ADDENDUM 1

The following information is forwarded to all qualified bidders for the above project for bids due June 1, 2026 at 3:00 PM. This addendum shall be signed by all BIDDERS and included with the Bid Form.

Reinforced Concrete Truck Apron - Paid as Item 608.38 - 8" Reinforced Concrete Sidewalk (F)

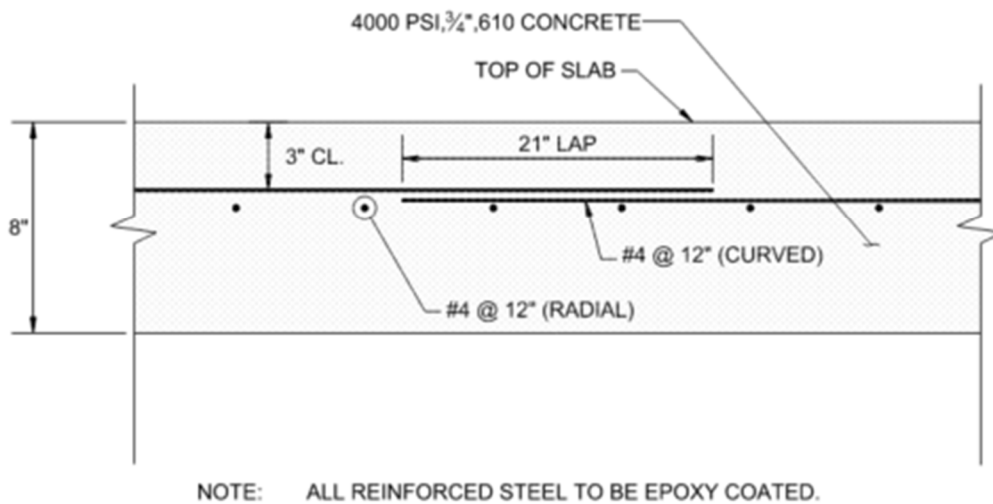
Q2: *There does not seem to be a reinforcing detail for the concrete truck apron.*

A: The apron should be reinforced. A detail is attached to this addendum.
